Subject: Arkansas Nuclear One - Units 1 and 2
Docket Nos. 50-313 and 50-368
License Nos. DPR-51 and NPF-6
Additional Information Regarding Technical Specifications Change
Request to Delete Reactor Coolant Pump Flywheel Inspections

Response to Questions Related to "Relaxation of Reactor Coolant Pump Flywheel Inspection Requirements"

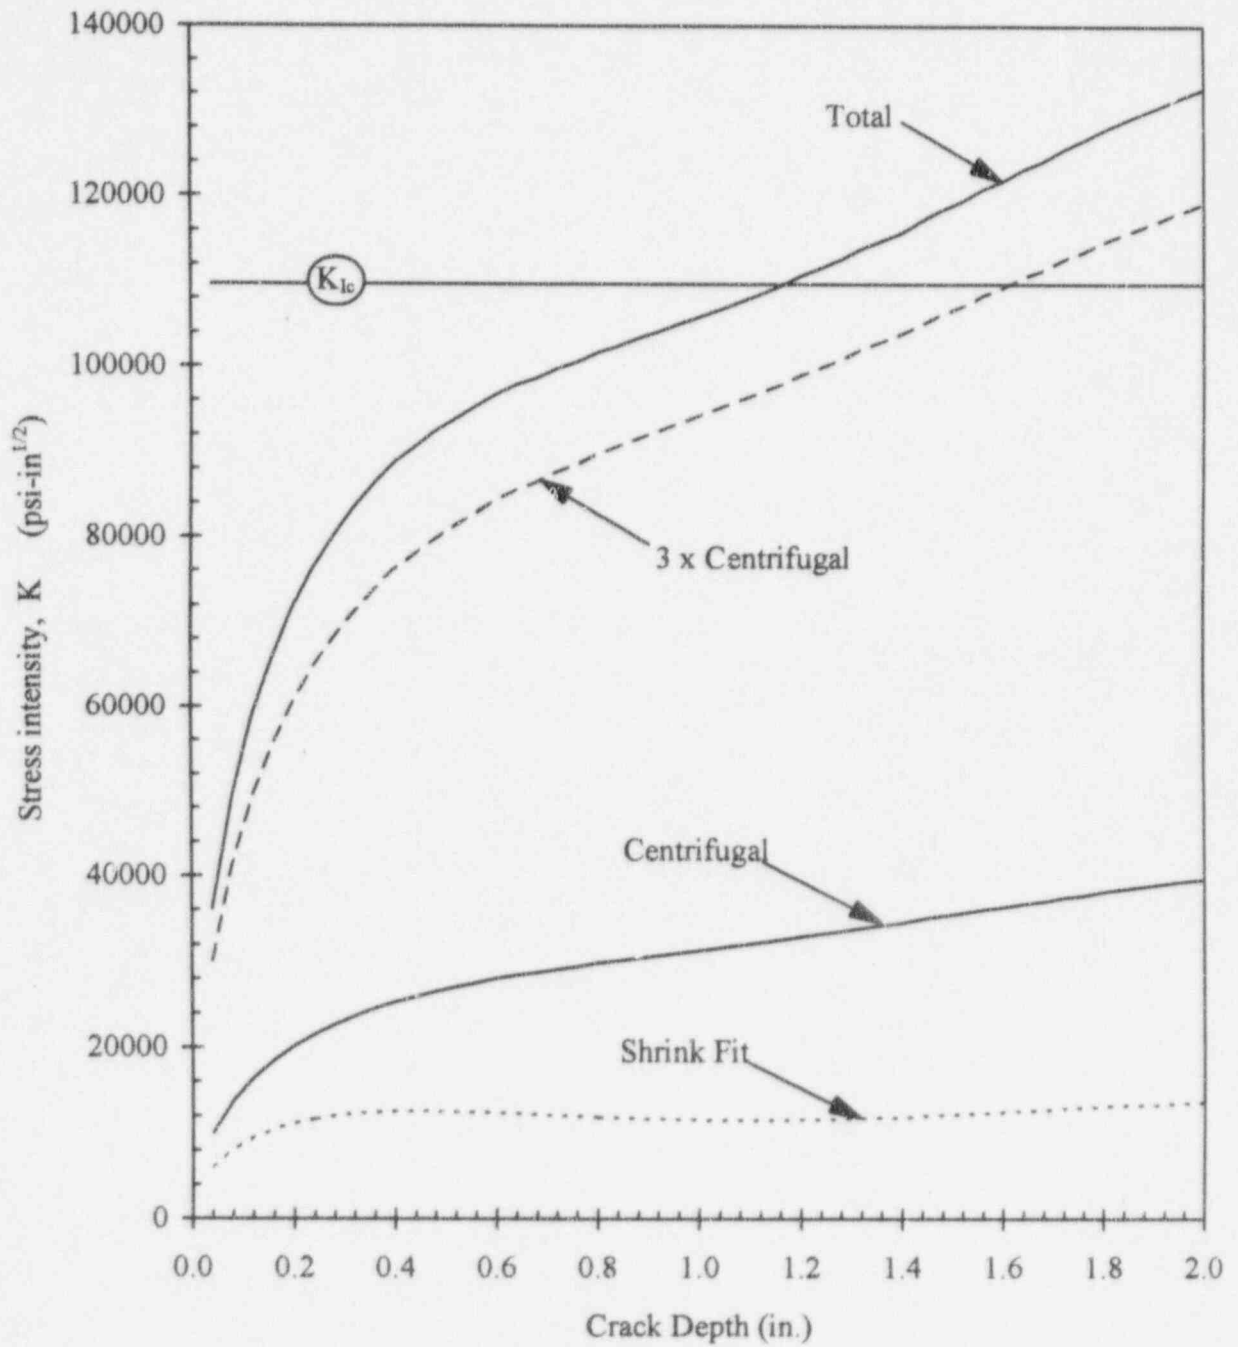
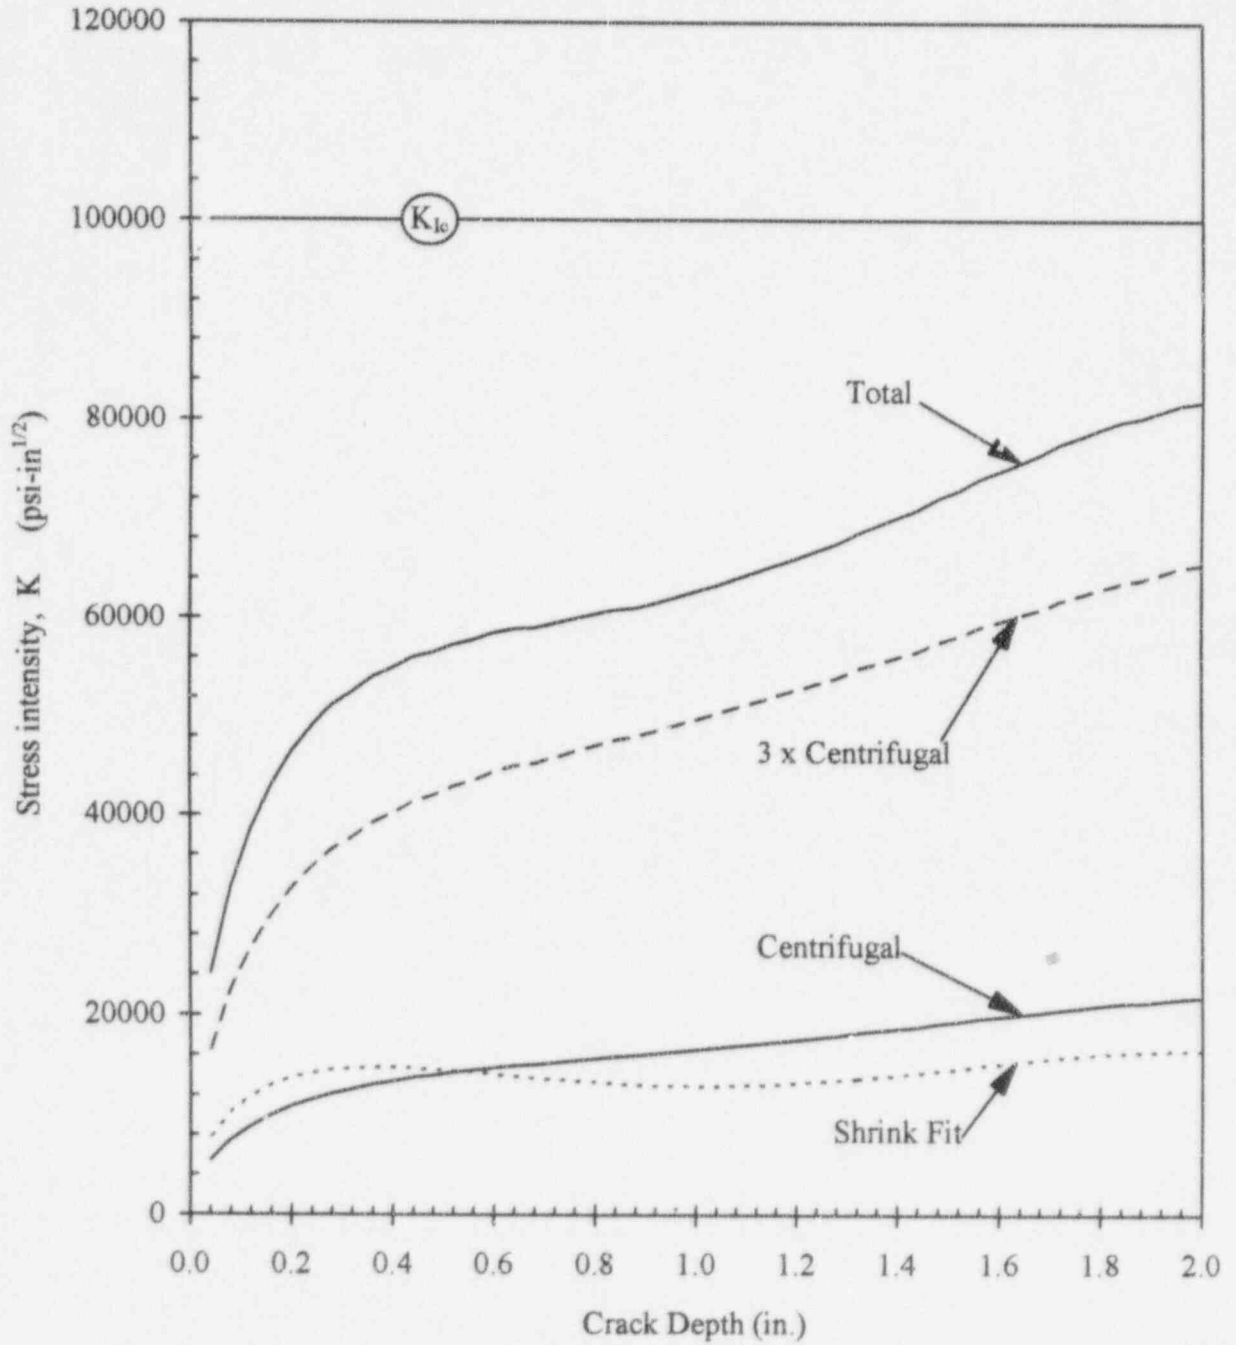
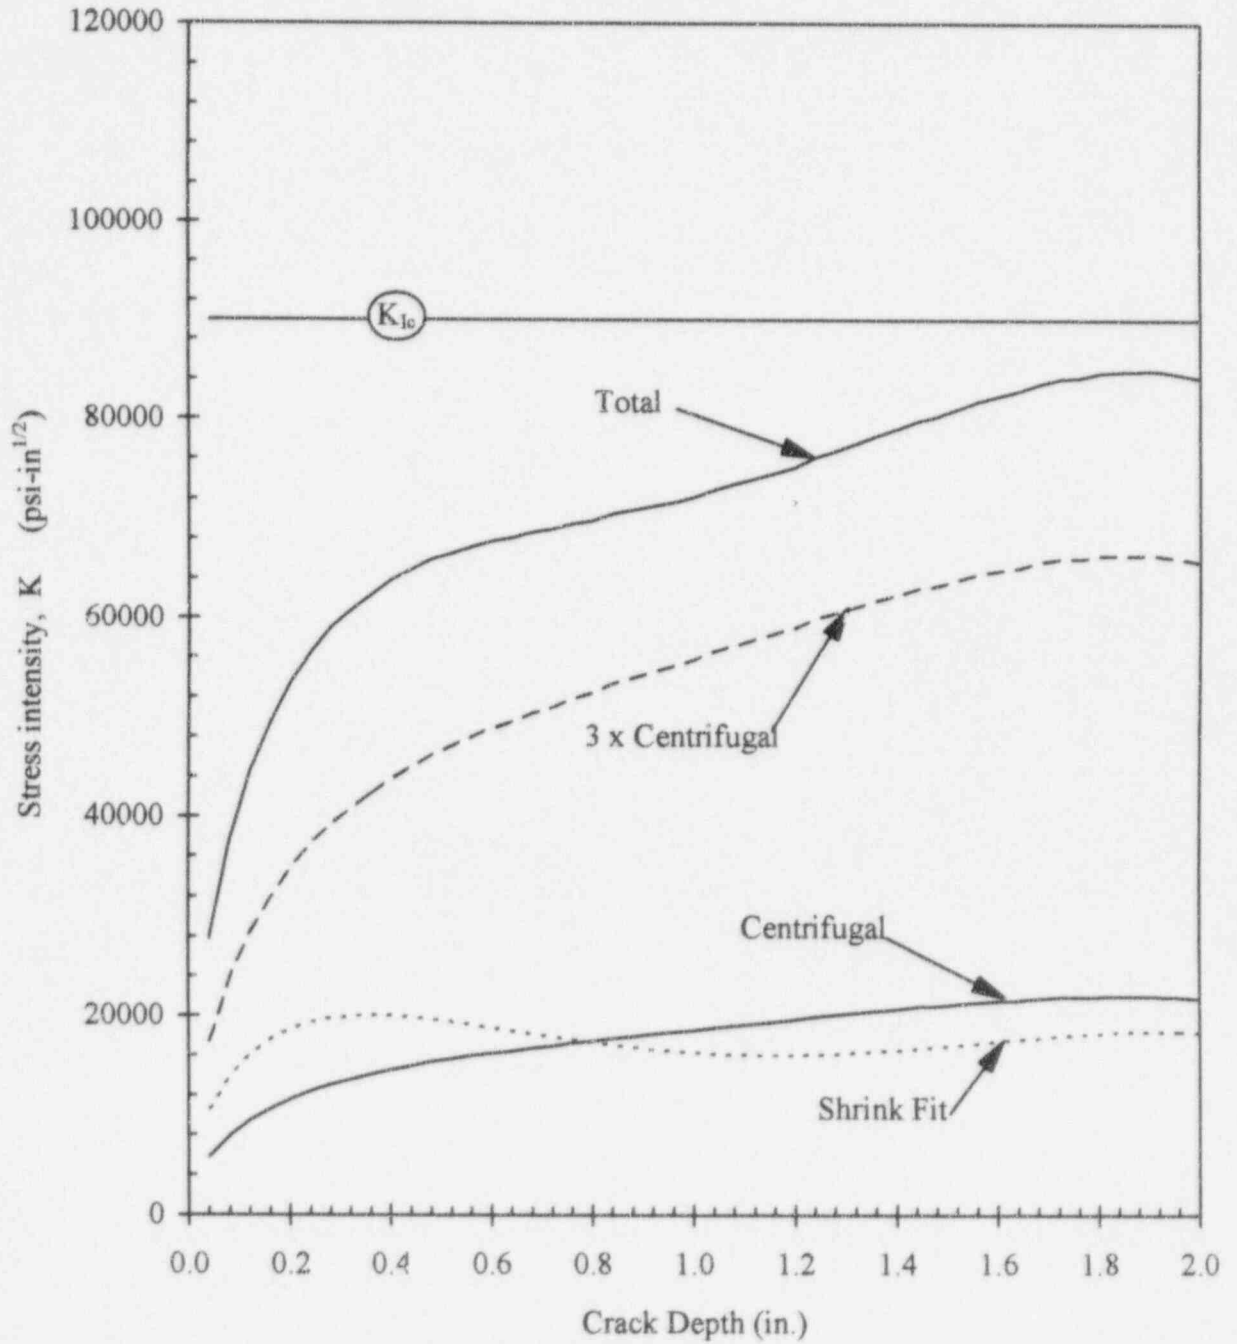
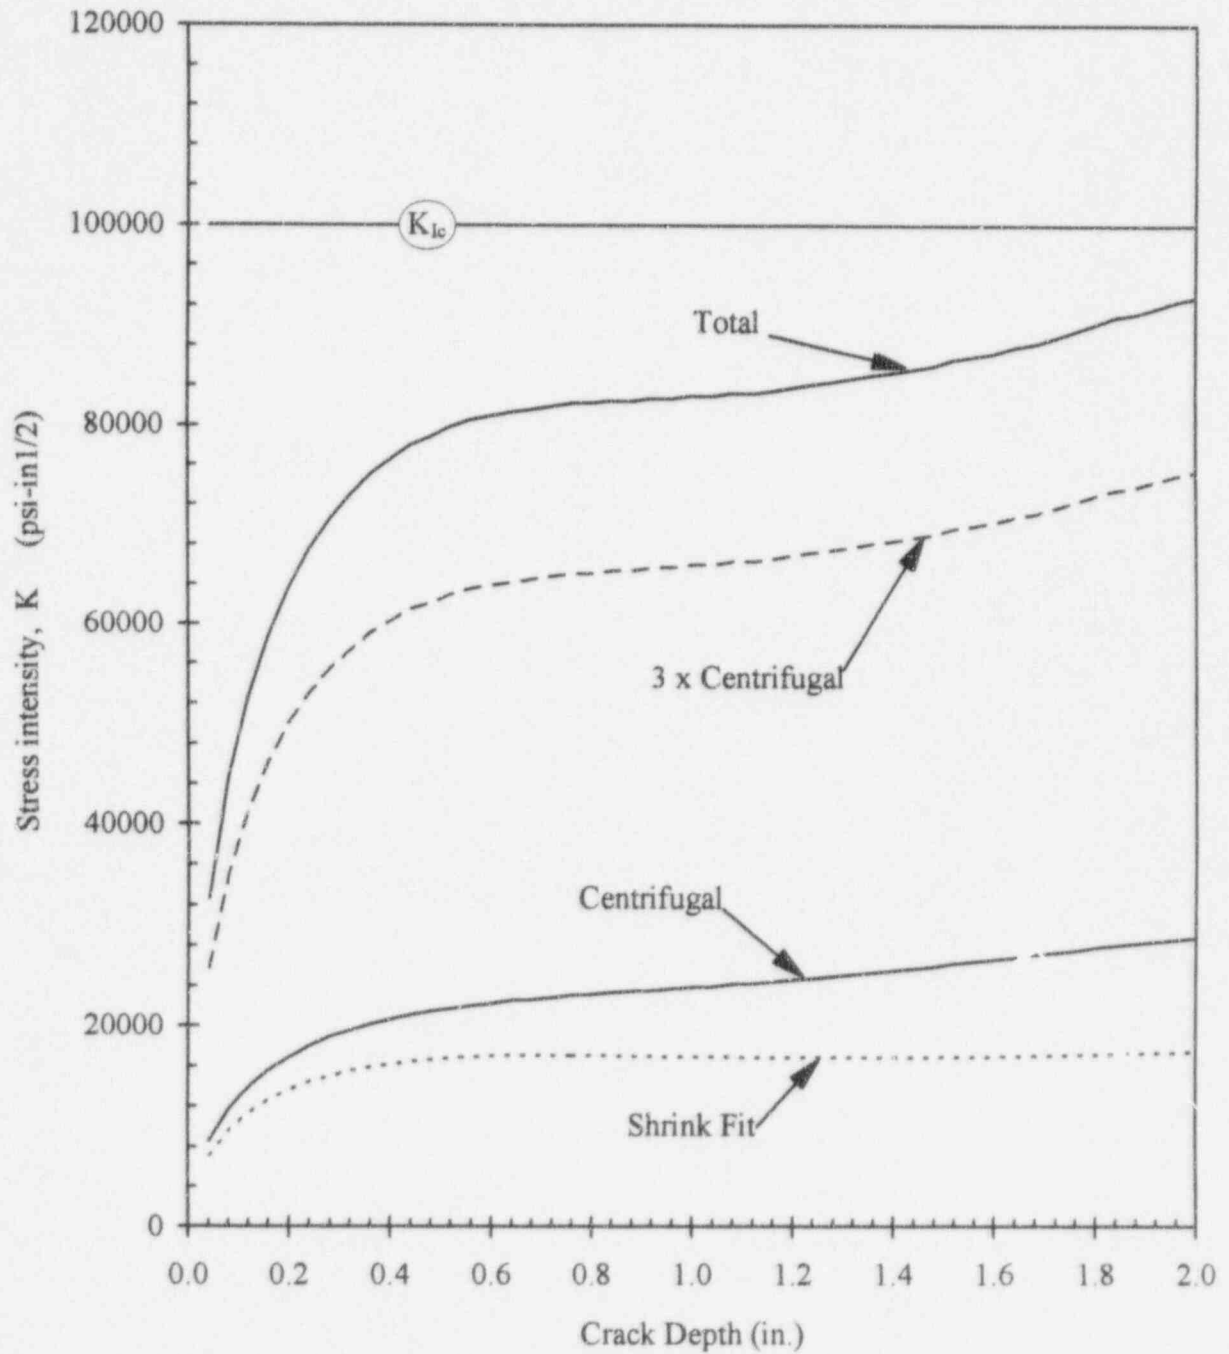
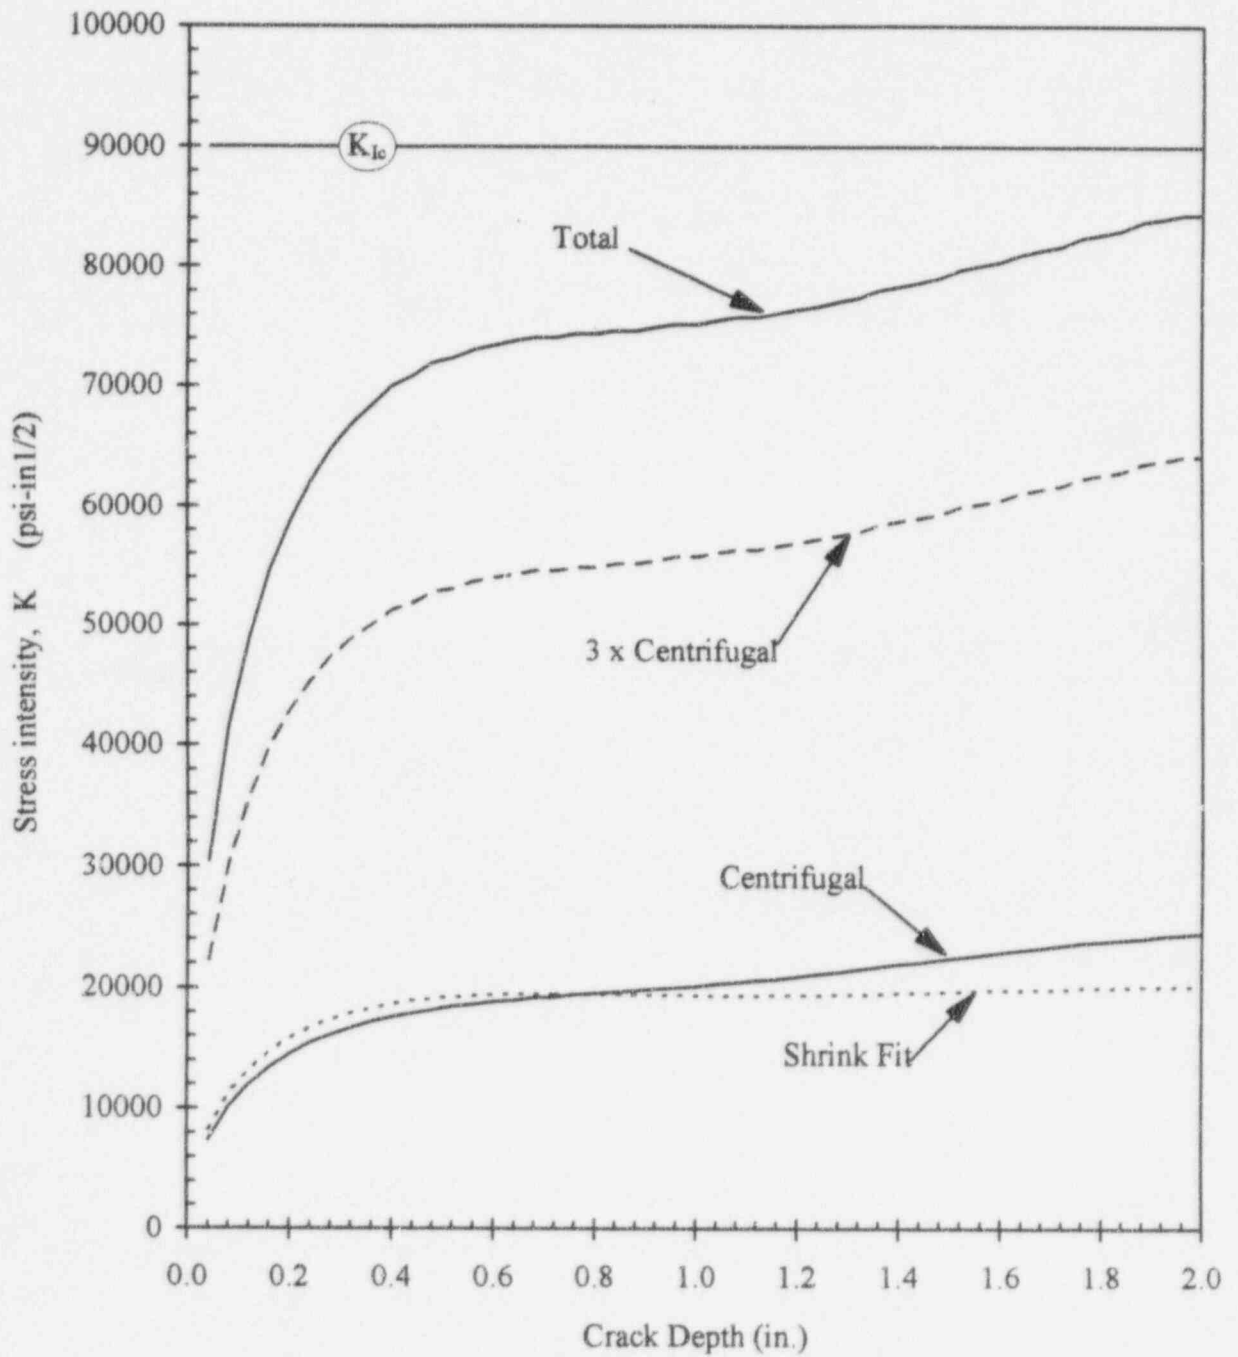
5. **Section 6.3, Allowable Flaw Size Determination, Pg. 6-6:** It was stated that the stress intensity distribution for the centrifugal and the shrink-fit stresses are compared separately with the allowable fracture toughness to determine the allowable flaw sizes. Under normal operating conditions, the staff believes that contributions from both centrifugal and shrink-fit stresses to the applied stress intensity factors are comparable and should be combined. Figures 6-3 through 6-8 indicate that when the combined effect is considered the ASME Code criteria may not be met even for the initial crack size of 0.25 inch. Clarify this. Also, provide a revised copy of Figures 6-3 and 6-14 by adding the stress intensity due to shrink fit at the proper speed to the stress intensity due to centrifugal load.

In the subject report, the centrifugal and the shrink-fit stresses were treated separately to determine the allowable sizes since the maximum stresses for these two loads do not occur at the same time. This approach was considered reasonable since very conservative shrink-fit values were used in the analysis (5.2 mils for the small-bore flywheels and 12.5 mils for the large-bore flywheels). In addition, the shrink-fit stresses are secondary (displacement type) stresses whose contribution to fracture is not as significant as the primary centrifugal stresses. It is expected that because of the very conservative initial shrink-fit values assumed in the analysis, that some amount of shrink-fit will still be present at the normal operating speed of the flywheel.

To determine the residual shrink-fit values at normal operating speed, the finite element analysis performed in support of the subject report was reviewed to determine the relative displacement (initial shrink-fit minus centrifugal displacement) at normal operating speed. This relative displacement was used to calculate the residual shrink-fit stresses at normal operating speed. Stress intensity factors calculated for the centrifugal and residual shrink-fit stresses at normal operating speed are shown in Figures 7 through 15 for all the flywheels that were evaluated in the subject report. For the large-bore flywheels, a model with t/R ratio of 1.2 was used to calculate the applied stress intensity factor and is shown in Figures 7 through 9. For the small-bore flywheels, stress intensity factors were calculated using t/R ratios of 1.2 and infinity as shown in Figures 10 through 15.

To determine the allowable flaw size, a safety factor of 3, consistent with ASME Code Section XI, was applied to the centrifugal stresses since these are primary stresses. A safety factor of 1 was applied to the shrink-fit stresses since these are displacement type stresses which do not contribute to the fracture of the ductile materials. All the flywheels operate in the upper shelf region and are therefore expected to exhibit very ductile behavior. Precedent for the use of a safety factor of 1 for secondary stresses has been established in ASME Code, Section XI, Appendix C for materials that exhibit elastic-plastic fracture behavior. The comparison of the total factored applied stress intensity factors with the fracture toughness for the flywheels are shown in Figures 7 through 15. The allowable flaw sizes resulting from these comparisons are shown in Table 3.

It can be seen that these allowable flaw sizes are greater than the final flaw sizes for the assumed initial flaws of 0.25 inches in the flywheels, even when the conservative shrink-fit stresses are considered in the evaluation and, even if a conservative model with $t/R = 1.2$ is used for the small-bore flywheels. This demonstrates that the conclusions of the subject report are not changed by inclusion of the secondary shrink-fit stresses in the determination of the allowable flaw sizes.
